VILLAGE OF ORLAND PARK

Plan Commission

Tuesday, October 10, 2017

[2017-0485](#) PDQ Restaurant, Lot 3 of 15610 LaGrange Retail Development (LFI) - Special Use Permit

WEST ELEVATION

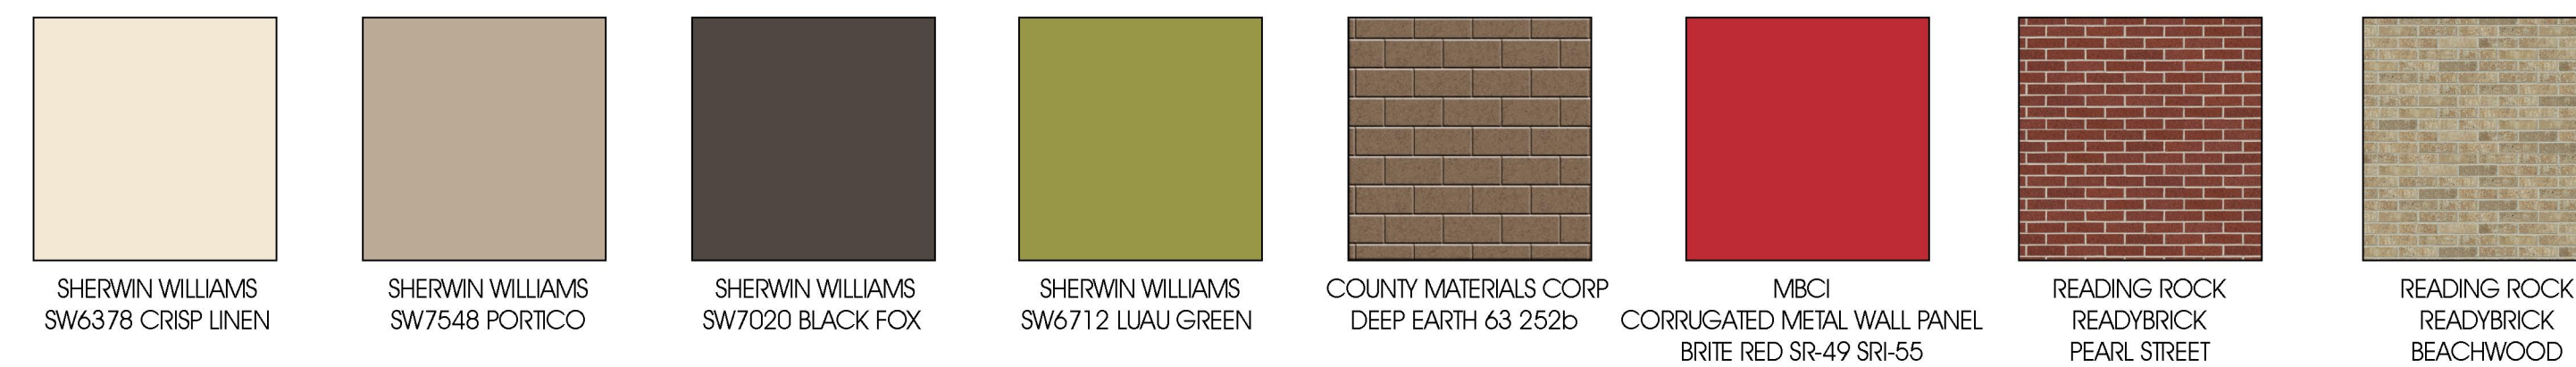
West Elevations- Sheet A2.0 and Exterior Elevations

The west elevation is mainly characterized by the drive-through entrance, a large window which is covered by long pre-fabricated aluminum sunshade green canopies, EIFS at the southern end of the parapet, and masonry brick pattern-work across the façade. Landscaping will screen the blank façade of the lower portion of this building. The petitioner is proposing painting the following PDQ branding, "People Dedicated to Quality" in white on the red parapet. This is not permitted by the Land Development Code, this will be addressed in the separate sign permit review.

EAST ELEVATION

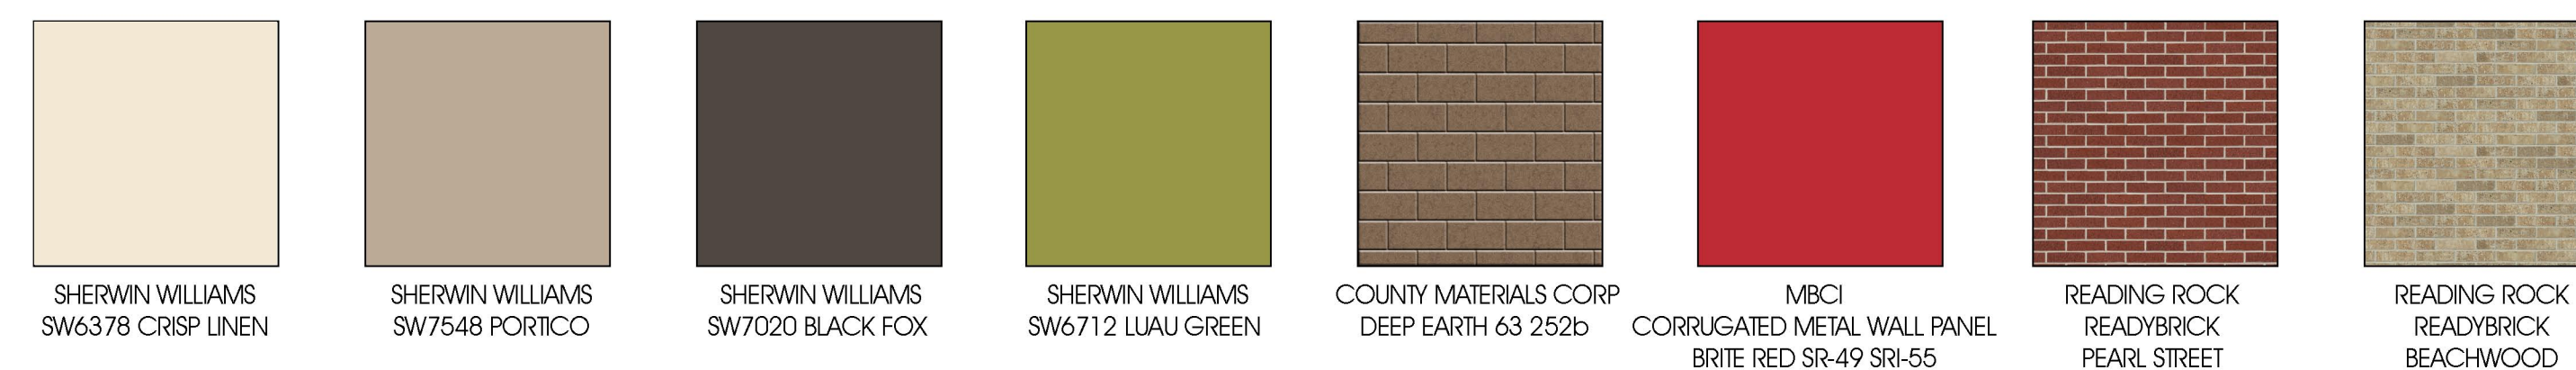
East Elevations - Sheet A2.1 and Exterior Elevations

The elevation is mainly characterized by the drive through facility pick-up window, large window, and pre-fabricated aluminum white trellis. The trellis along with the landscaping screens the drive-through lane from LaGrange Road. An enhanced buffer is created through the trellis and landscaping both to screen the drive-through facility and making the site visually appealing. Village staff worked closely with the petitioner to develop the trellis and landscaping screening for the drive-through facility between the building and the street (LaGrange Road) to accommodate PDQ's model for drive-through facilities. The landscaping screening will be described in more detail in the landscaping section. Landscaping will screen the blank façade of the lower portion of this building. A sign is included on the brick concrete masonry and will be reviewed separately in the sign permit review.
